DESCRIPTIVE REPORT

Registry No. H11623

General Locality Mobile Bay

Sublocality Fowl River Point to Pass aux Herons

Figure 2. Dton #7 least depth

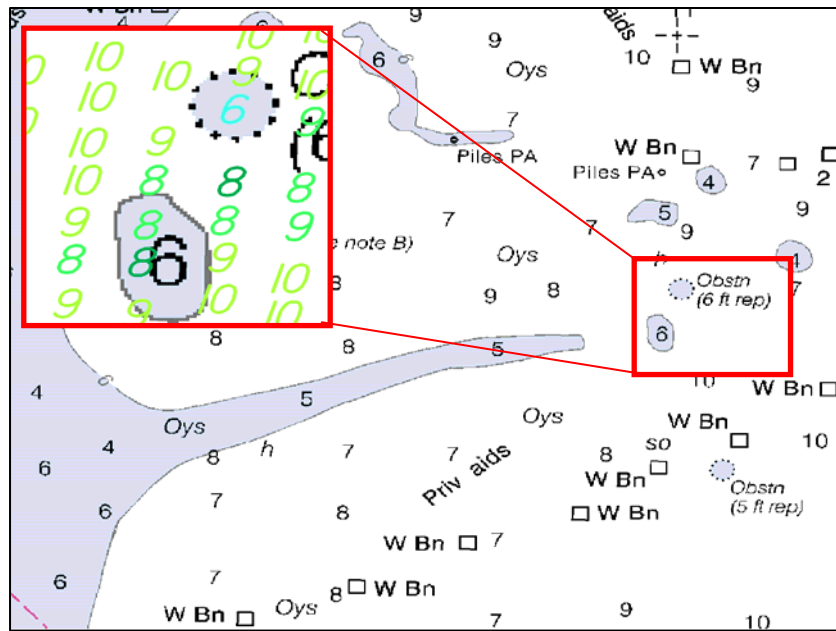
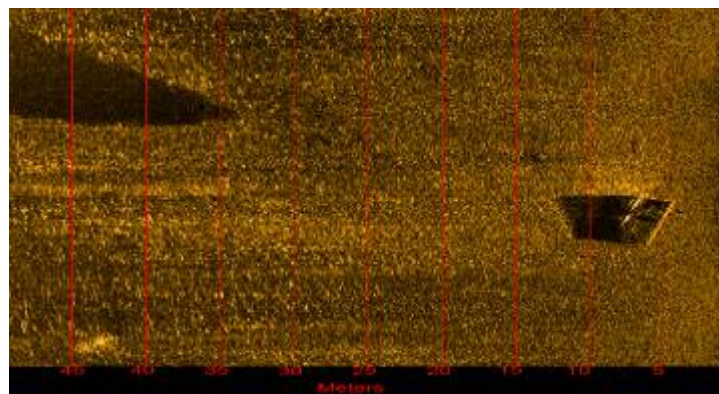
The six-foot shoal at 30-18-59.02N, 088-06-09.24W was disproved with 100% side scan sonar. There is no indication of shoaling in the side scan imagery. The single beam determined least depth over the charted shoal is 8 feet (2.4 m). **Concur.**

Coincidentally, the present survey located a side scan contact approximately 200m NNE of the charted shoal (Figures 2 and 3). The contact was submitted to the Atlantic Hydrographic Branch on April 12, 2007 as Danger to Navigation (Dton) #7 and has been applied to the chart. The submitted least depth was preliminary and based on side scan shadow length. Subsequent multibeam bathymetry was acquired and new least depths obtained. The hydrographer recommends removing the “reported” annotation and charting the obstruction depth of six feet (1.9 m). **Concur with clarification. Current chart status exists as an Obstrn (6-ft rep). Recommend to chart as a 6-ft (1.914m) Obstruction located in Latitude 30°19’05.62”N, Longitude 088°06’6.70”W, and delete (6 ft rep).**

Figure 4. 6-Foot least depth

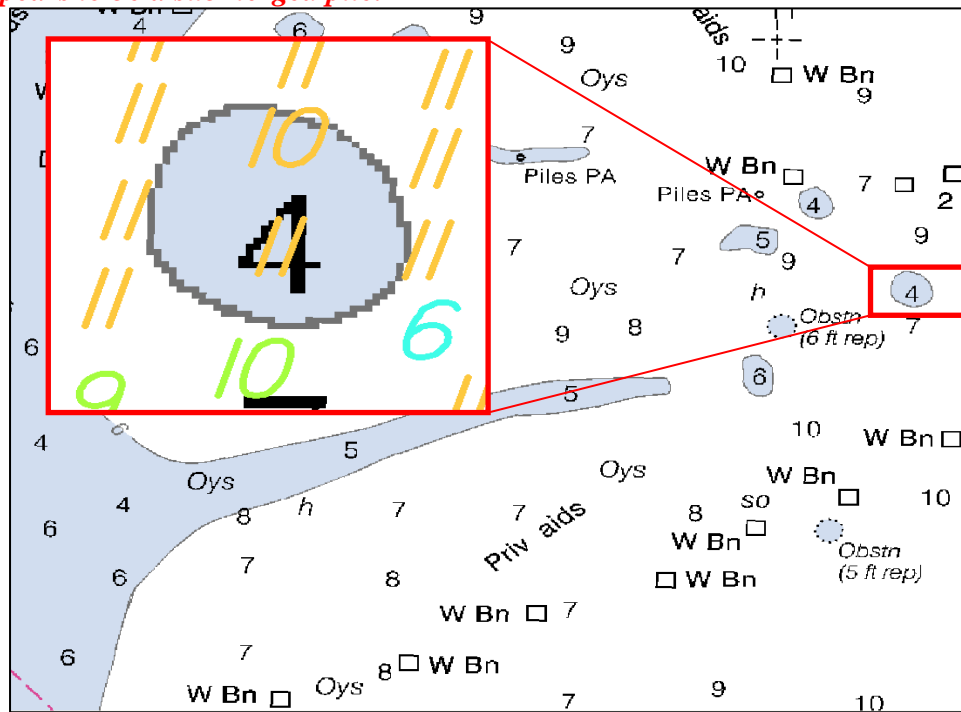
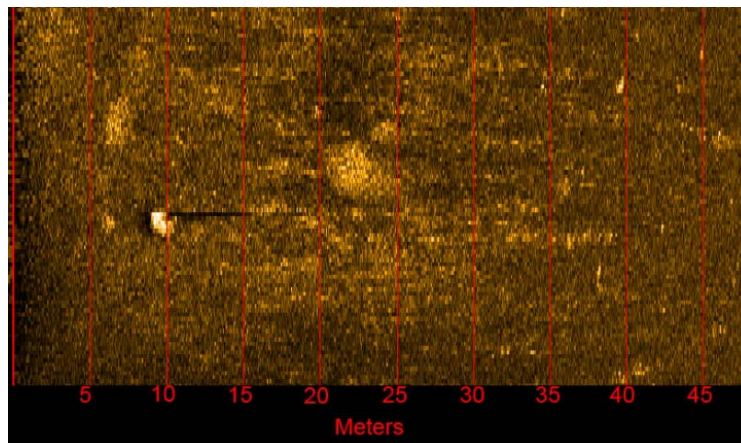
The charted four-foot shoal at 30-19-10.22N, 88-05-50.75W was disproved with 100% side scan sonar. No indication of a feature or shoaling is present in the side scan imagery at the charted position. The single beam least depth over the charted shoal is 10 feet (3.3 m). **Concur.**

Approximately 90 m to the SE (Figure 4), the current survey located a side scan contact (Figure 5) with a multibeam least depth of six feet (1.9 m). **Concur with clarification. Chart 6-ft (1.883m) Obstruction located Latitude 30°19'08.49"N, Longitude 088°05'47.62"W. The feature appears to be a submerged pile.**

Figure 6. Charted Features Comparison

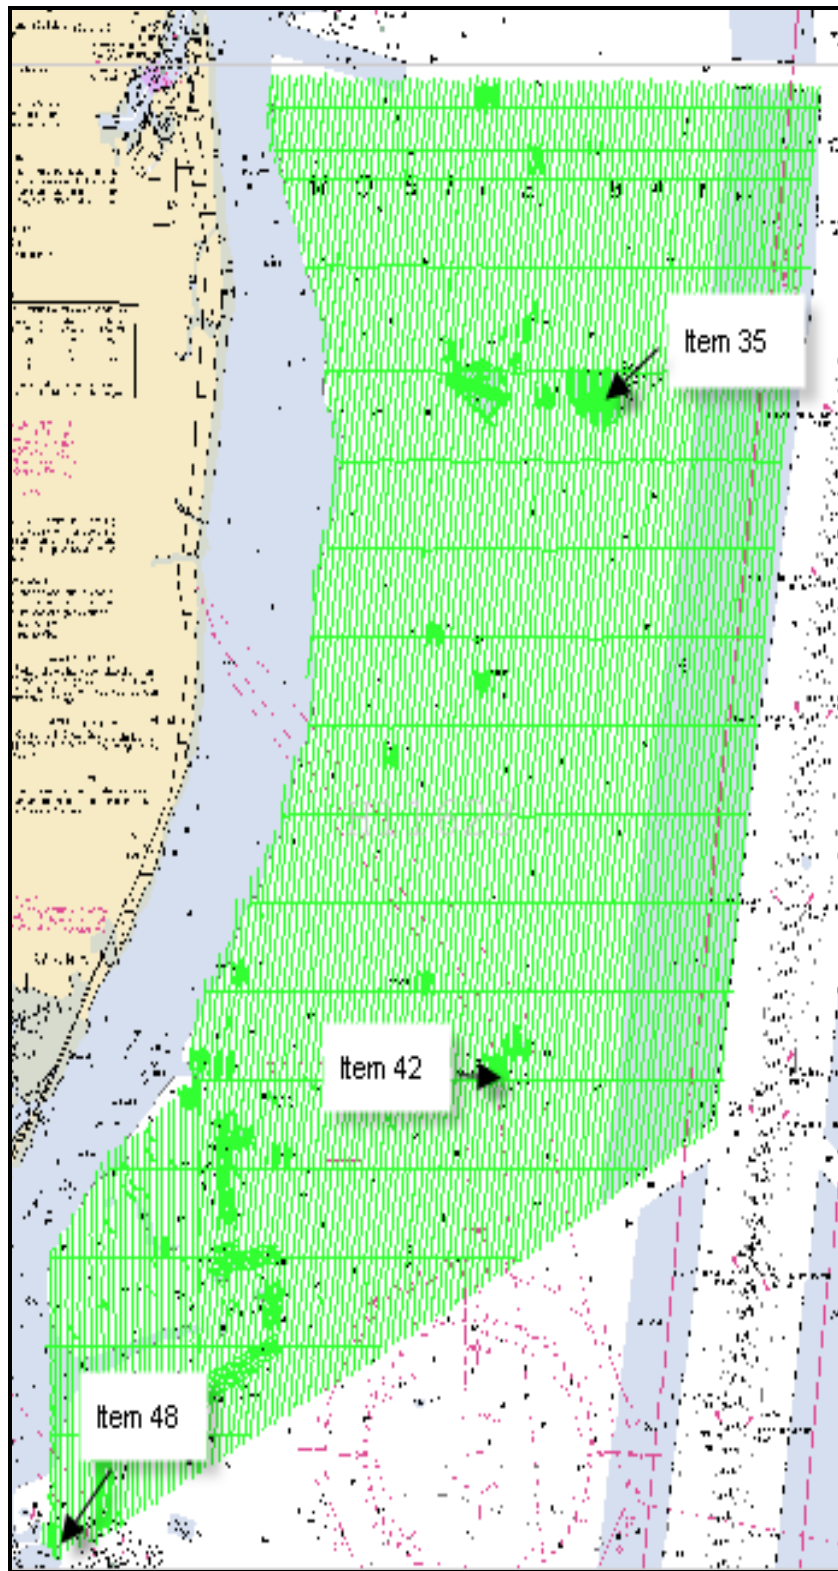
- The charted Obstruction Fish Haven (DEA charted feature item # CF35) at 30-24-41.04N, 088-03-04.93W, was disproved with 200% side scan sonar. The second 100% coverage was conducted over a set line spacing of 40 m at 25-meter range scale. The side scan sonar, single beam and visual search was conducted over a radius of 670 m. A new fish haven was positioned approximately 950 m to the west and submitted to AHB as DtoN #2 on April 10, 2007. **Concur. Recommend to delete charted Obstruction Fish Haven (auth min 8 ft).**

- The charted Obstruction Fish Haven (DEA charted feature item # CF42) at 30-20-36.21N, 088-03-53.97W was disproved with 200% side scan sonar. The second 100% coverage was conducted over a set line spacing of 40 m at 25-meter range scale. The side scan sonar, single beam, and visual search was conducted over a radius of 280 m. The minimum depth in the area is 12 feet. **Concur. Recommend to delete charted Obstruction Fish Haven (auth min 7 ft).**

- The charted Obstruction Tank (DEA charted feature item # CF48) is also an AWOIS item and is discussed in Section D1.e of this report. **Refer to AWOIS Item 3514, Section D1.e, page 18.**

Figure 7. Submitted DtoN #4; **final** least depth 8.8 feet (2.694 m)

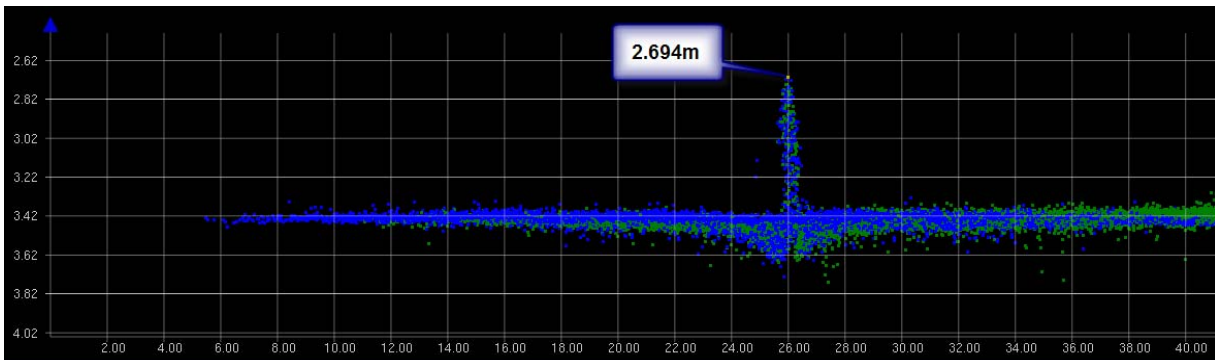
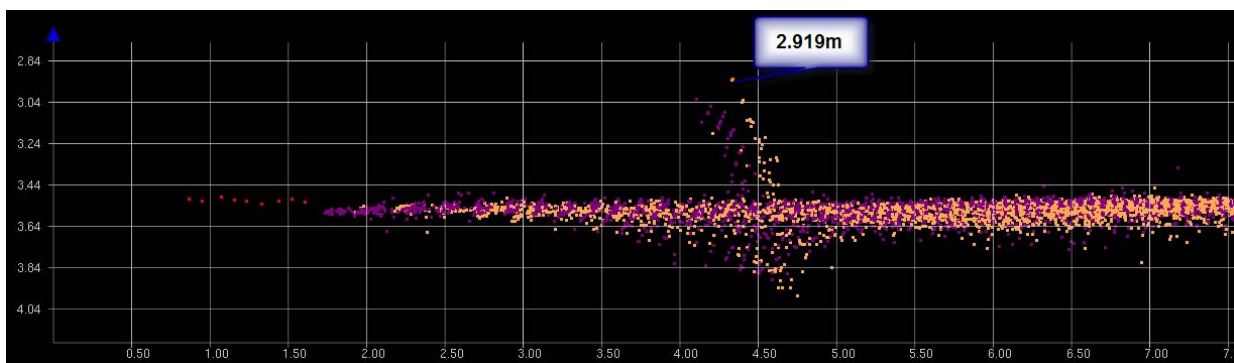
H11623 includes one anchorage ground, designated as 110.194a, near Cedar Point. Generally, depths increase in the anchorage to the east and range from 10 feet to 12 feet. Two new obstructions were located by this survey in the anchorage area and were submitted as DtoNs # 4 and # 5, respectively, to AHB on April 10, 2007. The submitted least depths were preliminary and based on side scan shadow length. Subsequent multibeam bathymetry was acquired and new least depths obtained (Figures 7 and 8). The hydrographer recommends removing the “reported” annotation and charting both with the least depth of 9 feet at the S-57 attributed position. **Concur with clarification. DToN # 4 was originally submitted as 8-ft (2.62m) OBSTRN, located in 30°20’23.17”N, 088°05’45.20”W. Final depth value is 8.83-ft (2.694m). Delete charted Obstruction (8 ft rep). Chart 9-ft (2.694m) Obstruction in Latitude 30°20’23.17”N, Longitude 088°05’45.20”W.**

DToN#5 was originally submitted as an 8-ft (2.62m) OBSTRN located in Latitude 30°20’28.17”N, Longitude 088°05’25.67”W. Final depth value is 9.58-ft (2.919m). Delete charted Obstruction (8 ft rep). Chart 9-ft Obstruction in Latitude 30°20’28.10”N, Longitude 088°05’25.77”W.

Figure 9. Depths near safety fairway shoal areas displayed in yellow

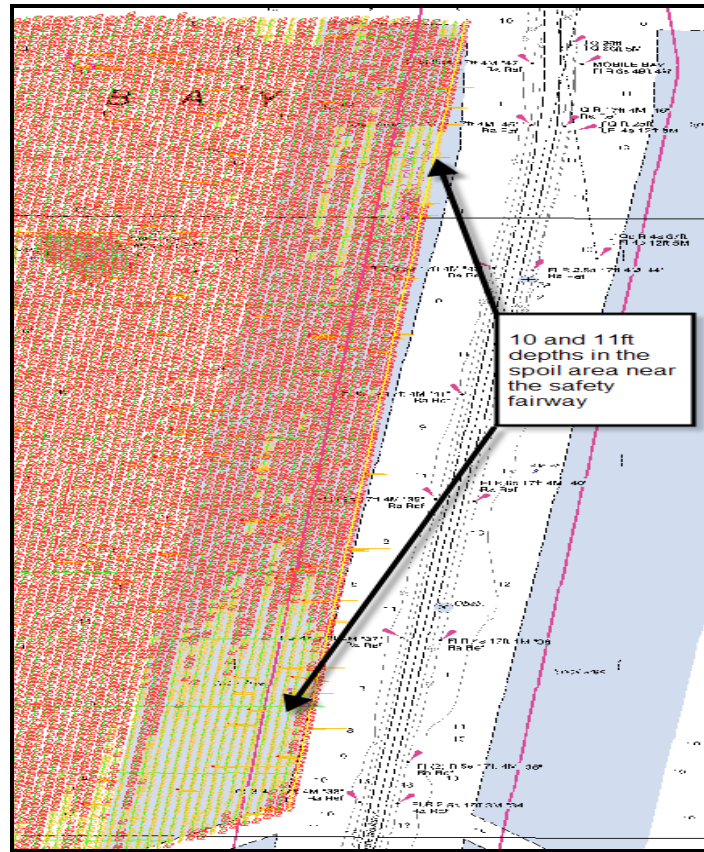
The eastern extent of H11623 is bounded by a spoil area immediately to the west of Mobile Bay Safety Fairway 116.200 (Figure 9). Depths along the channel line are generally 12 feet (shown in the figure below in red) with the exception of two areas that shoal to 10 feet to 11 feet (shown as yellow). *Concur.*

Figure 10. AWOIS Items on H11623

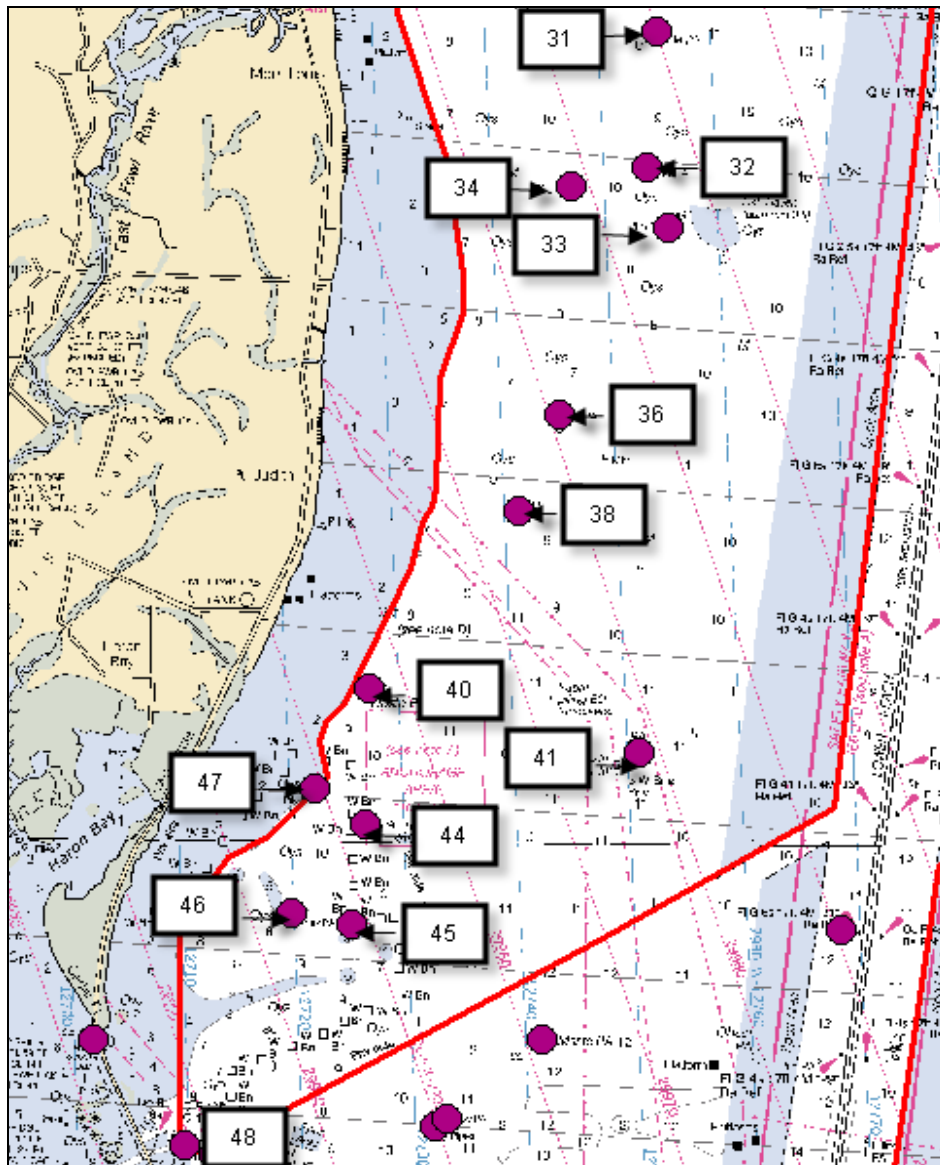
- The PA Pile (AWOIS Item 3559) at 30-26-11.83N, 088-03-36.89W was disproved with 200% side scan (DEA charted feature item # CF31). **Concur. Consider Pile PA disproved, delete from chart.**
- The PA Pile (AWOIS Item 3561) at 30-25-08.60N, 088-03-40.02W was disproved with 200% side scan (DEA charted feature item # CF32). **Concur. Consider Pile PA disproved, delete from chart.**

- The PA Pile (AWOIS Item 3563) at 30-24-43.78N, 088-03-30.52W was disproved with 200% side scan (DEA charted feature item # CF33). **Concur. Consider Pile PA disproved, delete from chart.**

- The PA Pile (AWOIS Item 3562) at 30-25-00.33N, 088-04-17.37W was disproved with 200% side scan (DEA charted feature item # CF34). **Concur. Consider Pile PA disproved, delete from chart.**

- The PA Pile (AWOIS Item 3564) at 30-23-16.39N, 088-04-24.91W was disproved with 200% side scan (DEA charted feature item # CF36). **Concur. Consider Pile PA disproved; delete from chart.**

- The Wreck (AWOIS Item 3565) at 30-22-31.18N, 088-04-46.64W was disproved with 200% side scan sonar (DEA charted feature item # CF38). **Concur. Consider visible Wreck PA disproved; delete from chart.**

- The PA Obstruction (AWOIS Item 3566) at 30-21-09.96N, 088-06-00.56W was disproved with 200% side scan sonar (DEA charted feature item # CF40). **Concur. Consider Obstruction PA disproved; delete from chart.**

- The PA piles (AWOIS Item 3525) at 30-20-23.85N, 088-06-27.66W was disproved with 200% side scan sonar (DEA charted feature item # CF47). **Concur. Consider Pile PA disproved; delete from chart.**

- The PA piles (AWOIS Item 3527) at 30-19-27.85N, 088-06-39.16W were disproved with 200% side scan sonar. Numerous new piles to the NE and SE marking a no shrimping area, were submitted to AHB as DtoN #1 on April 3, 2007 (DEA charted feature item # CF46). **Concur. Consider Pile PA disproved; delete from chart. Also refer to DR Appendix 1 regarding Danger #1 submission.**

- The PA piles (AWOIS Item 3528) at 30-19-23.19N, 088-06-09.49W were disproved with 200% side scan sonar. Numerous new piles to the NE and SE marking a no shrimping area, were submitted to AHB as DtoN #1 on April 3, 2007 (DEA charted feature item # CF45). **Concur. Consider Pile PA disproved; delete from chart. Also refer to DR Appendix 1 regarding Danger #1 submission.**

- The PA wreck (AWOIS Item 3529) at 30-20-43.30N, 088-03-41.94W was disproved with 200% side scan sonar (DEA charted feature item # CF41). A large contact was located approximately 100 m north of the disproved charted wreck. and is discussed in Section D1.f of this report. The hydrographer recommends removing PA annotation and wreck symbol and charting new obstruction at the S-57 attributed position. **Concur with clarification. Delete charted dangerous wreck PA located in Latitude 30°20'43.3"N, Longitude 088°03'41.94"W. DR Section D1.f makes no reference to AWOIS #3529 or to the barge located during H11623. AWOIS #3529 was considered disproved at the charted location;**

- The charted Obstruction Tank (AWOIS Item 3514) at 30-17-40.66N, 088-07-31.82W, was disproved with 200% side scan sonar. The second 100% coverage was conducted over a set line spacing of 40 m at 25-meter range scale. The side scan sonar, single beam, and visual search was conducted over a radius 200m (DEA charted feature item # 48). **Concur with clarification. Consider Obstruction (tank) disproved at the charted location. Recommend to delete charted Obstruction (tank).**

Figure 11. Position Approximate Wreck located on H11623

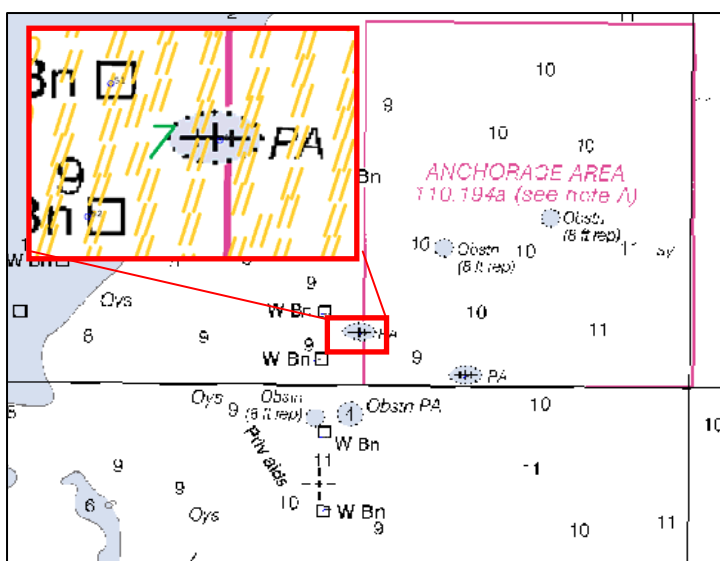
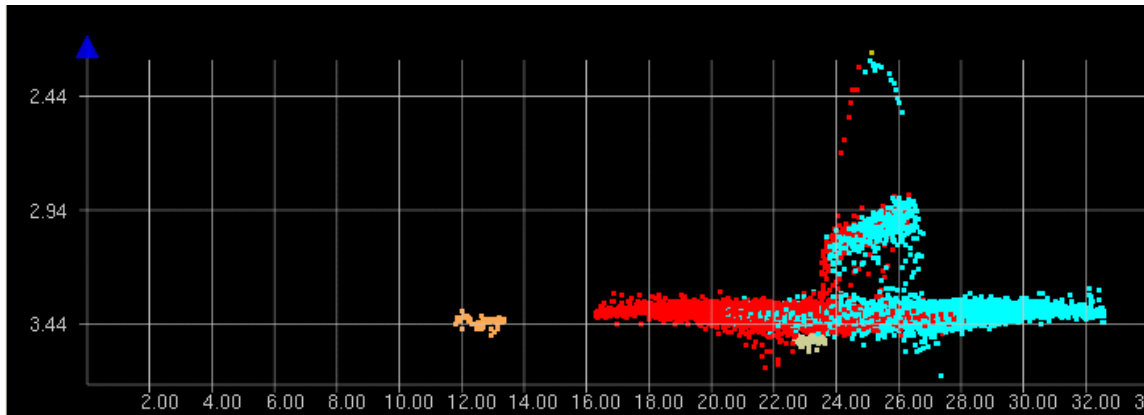
- The PA Wreck (AWOIS Item 3526) was located by this survey by 200% side scan and 100 % multibeam. The least depth of 7 feet (2.25 m) appears to be from line floating off of the wreck (Figure 12). The hydrographer recommends charting the center of the wreck at 30-20-09.09N, 088-06-03.98W and removing the PA annotation (DEA charted feature item # 44). **Concur with clarification. SS imagery of the feature supports the MB data points. The least depth is approximately 1.2m above the seafloor. Recommend charting a 7-ft (2.225m) wreck at the surveyed position in Latitude 030°20'09.09"N, Longitude 088°06'03.98"W. Recommend revising AWOIS 3526 to the surveyed location and delete wreck PA at the charted location in Latitude 30°20'09.22"N, Longitude 088°06'00.61"W.**

Figure 13. Charted Position Approximate features

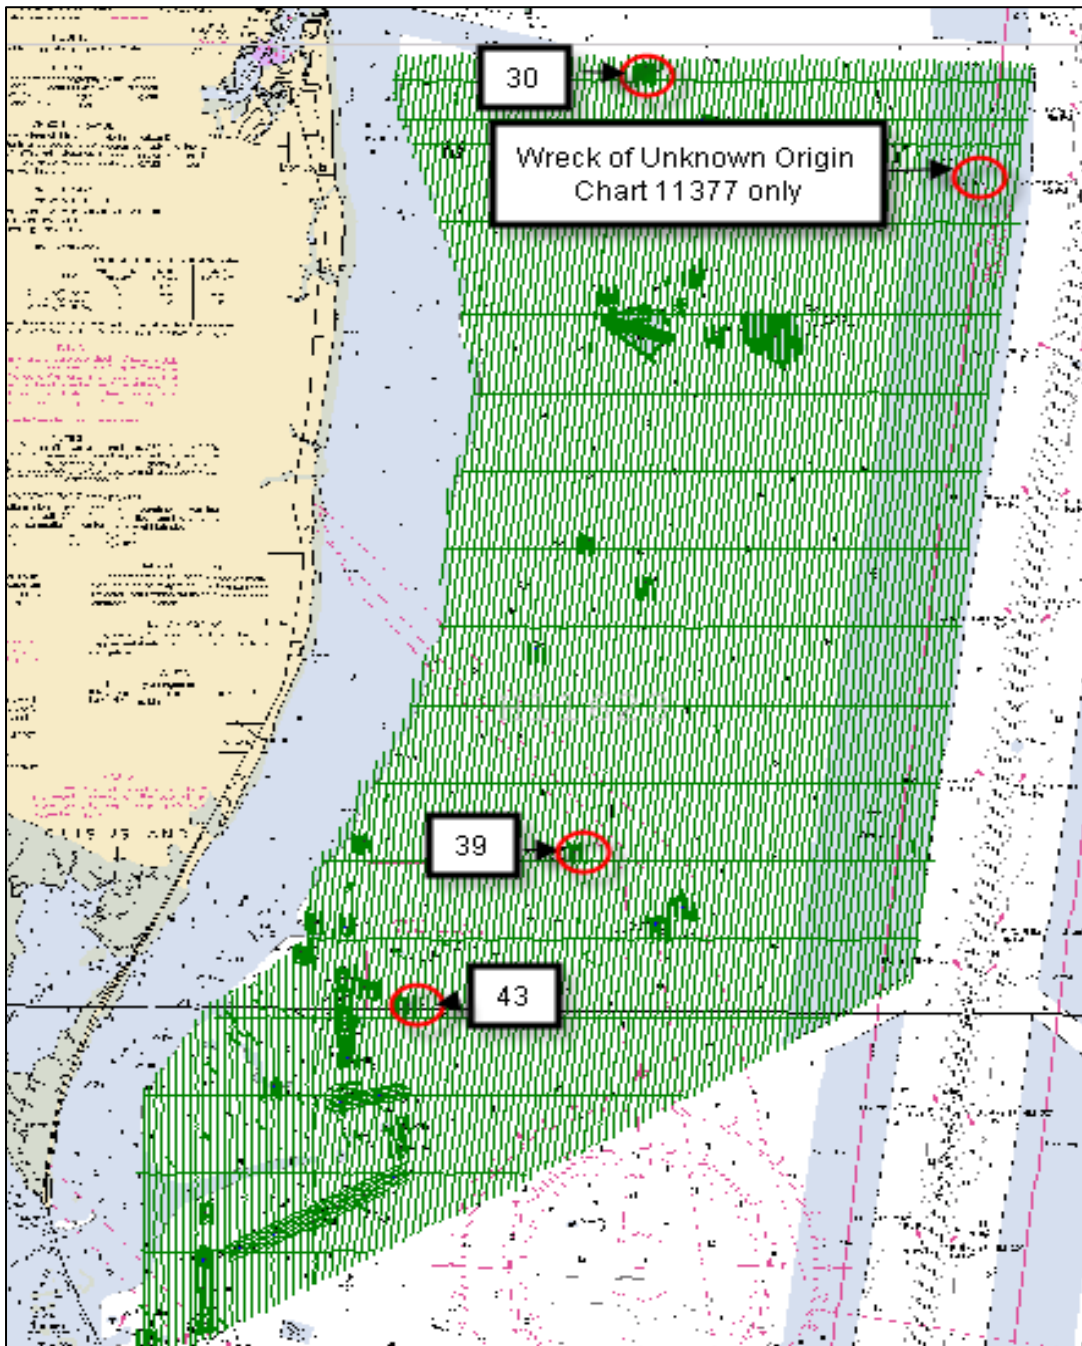
- The PA Wreck at 30-26-33.2N, 088-04-02.14W was disproved with 200% side scan sonar. (DEA charted feature item # CF30) **Concur. Consider wreck PA disproved, delete charted wreck PA.**

- The PA wreck at 30-20-02.18N, 088-05-40.80W was disproved with 200% side scan sonar (DEA charted feature item # CF43) **Concur. Consider wreck PA disproved, delete charted wreck PA.**

- The Subm pile ED (uncovers) at 30-21-05.89N, 088-04-29.76W was disproved with 200% side scan sonar (DEA charted feature item # CF39). **Concur. Consider Subm pile ED (uncovers) disproved, delete charted Subm pile ED.**

- A PA Wreck at 30-25-54.17N, 088-01-55.06W only appears on Chart 11377 and was added after the completion of survey operations on H11623. The wreck is of an unknown source and is not listed in the LNM from April (survey completion) to the time of this writing, nor is it included in the AWOIS database. The wreck was not observed in the 100% side scan coverage. **Concur. Consider disproved, delete charted wreck PA.**
